California Department of Fish and Game
North Central Coast Study Region
Feasibility Evaluation of Draft MPA Proposals
February 11, 2008

Draft MPA Proposal 2 (JD)

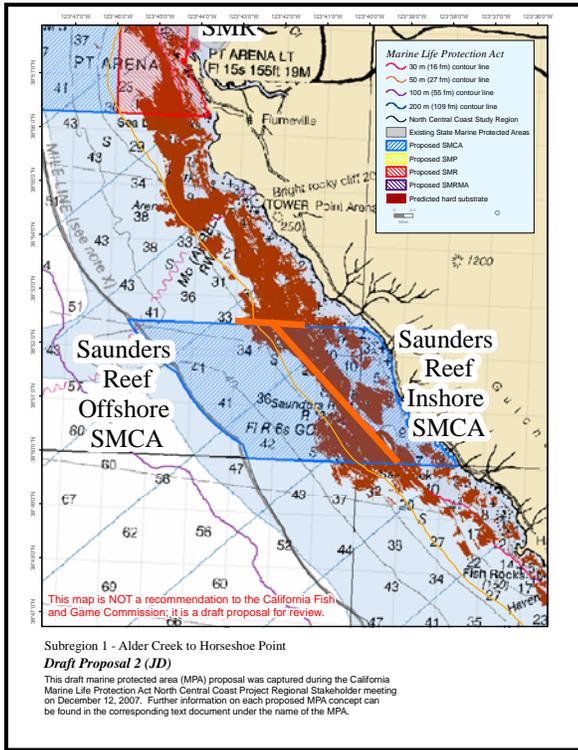
Pt. Arena SMCA and SMR: Floating corners were created in the north-eastern, north-western and south-western corners of Pt. Arena SMR. Offshore corners should be located at whole minute lines of latitude and longitude (see: general suggestions for improving the feasibility of the draft proposals; bullet #2).

- Floating corners are difficult to enforce.

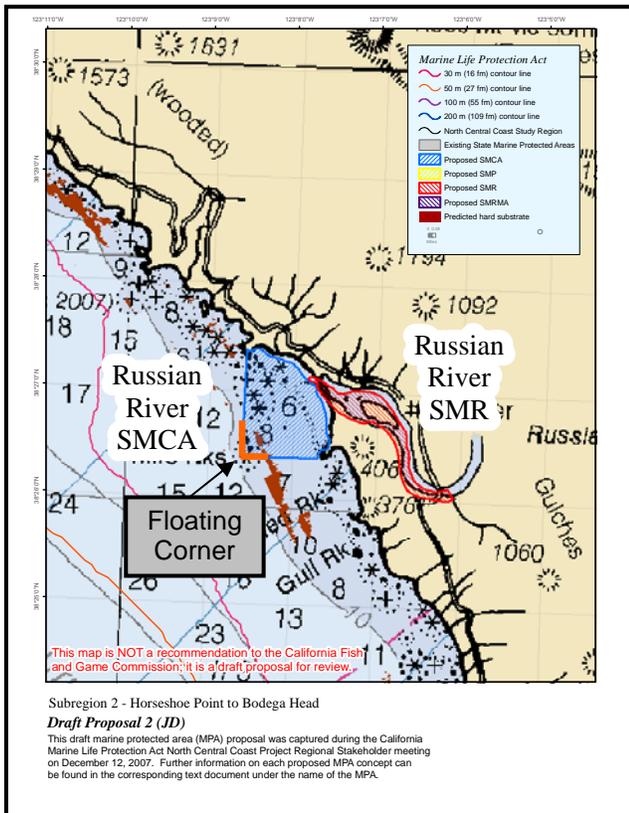
Salt Point SMP and Gerstle Cove SMR: Doughnut design with Gerstle Cove SMR inside of Salt Point SMP. The western boundary of Salt Point SMP is an unanchored diagonal line. Diagonal lines may be feasible when they follow the angle of the coastline and are anchored at whole minute points of latitude and longitude.

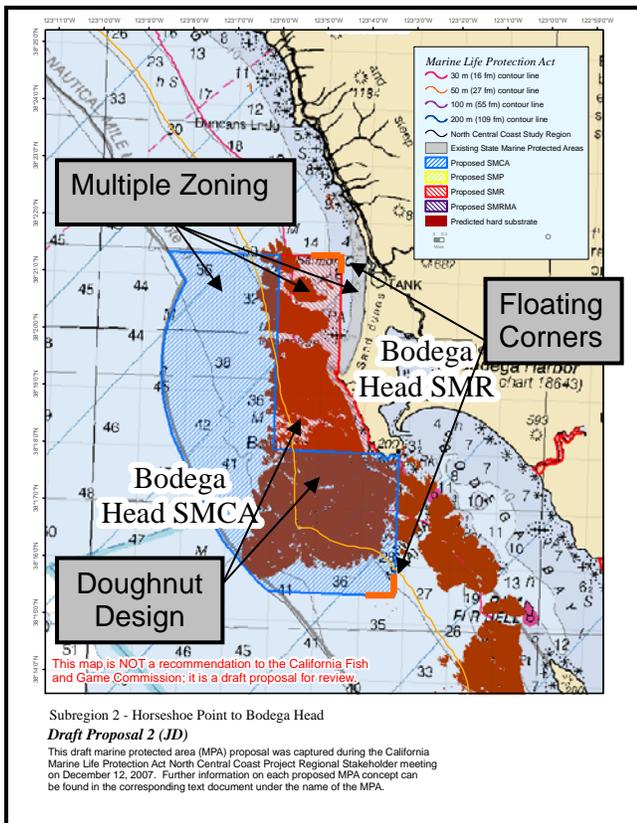
Russian River SMR and SMCA: A floating corner was created in the south western corner of the SMCA (see External Proposal A (round 2) for a similar sized/ positioned MPA using coordinates that meet feasibility guidelines). Offshore corners should be located at whole minute lines of latitude and longitude (see: general suggestions for improving the feasibility of the draft proposals; bullet #2).

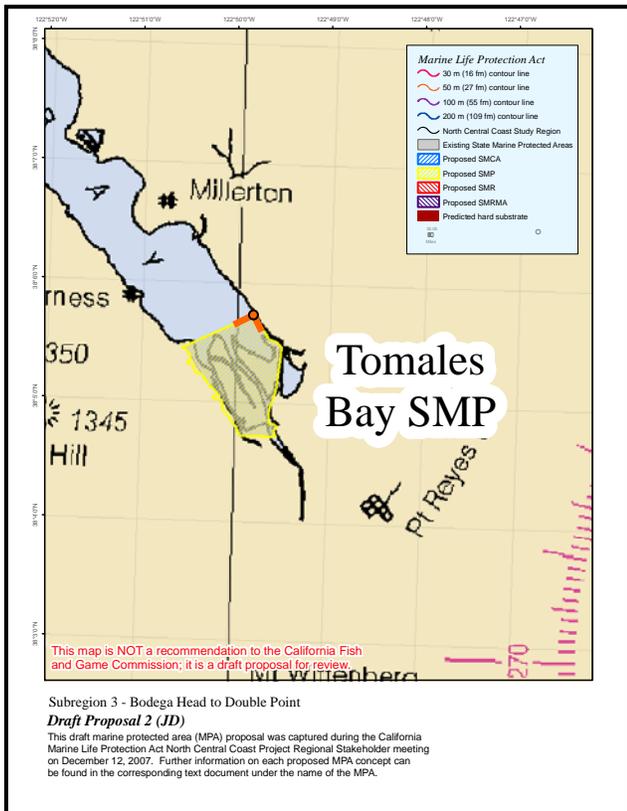
Bodega Head SMR and SMCA: Doughnut design with Bodega Head SMR surrounded on two sides by Bodega Head SMCA. Multiple zoning was created in the northern portion of this cluster with Bodega Head SMCA, Bodega Head SMR and nearshore non-MPA designated waters. Multiple designations in a small area are difficult to enforce and create confusion among user groups. Floating corners were created in the north-western corner of Bodega Head SMR and the south-western corner of Bodega SMCA. Offshore corners should be located at whole minute lines of latitude and longitude (see: general suggestions for improving the feasibility of the draft proposals; bullet #2).

- Enforceability and public understanding would be enhanced by simplifying this cluster.
- Suggest changing the take regulations to crab instead of Dungeness crab to ease enforcement of the area.

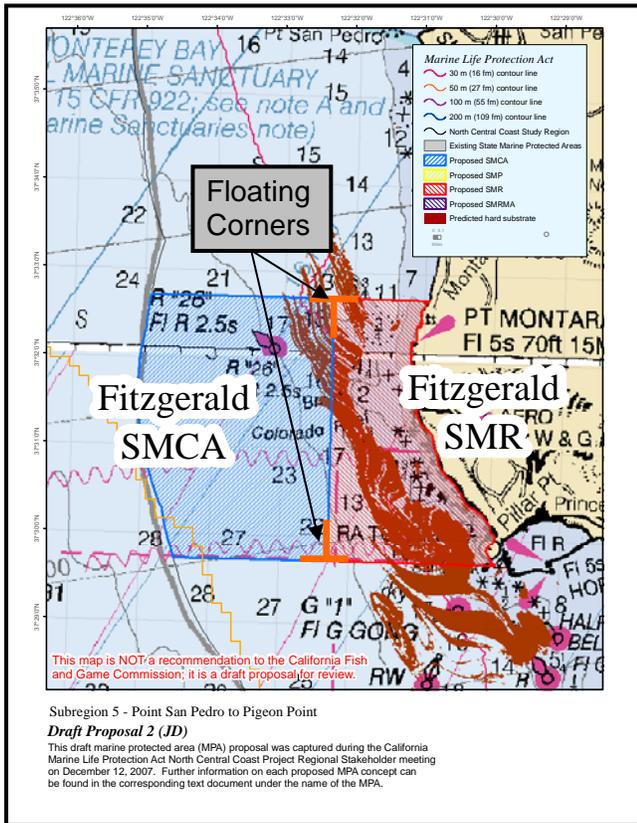
Pt. Reyes SMR and SMCA: Doughnut design with Point Reyes SMR surrounded on four sides by Point Reyes SMCA. Floating corners were created in the north-eastern, south-western and south-eastern corners of Pt. Reyes SMR. Offshore corners should be located at whole minute lines of latitude and longitude (see: general suggestions for improving the feasibility of the draft proposals; bullet #2).

- Floating corners are difficult to enforce.
- This area is remote and a long response time is expected.
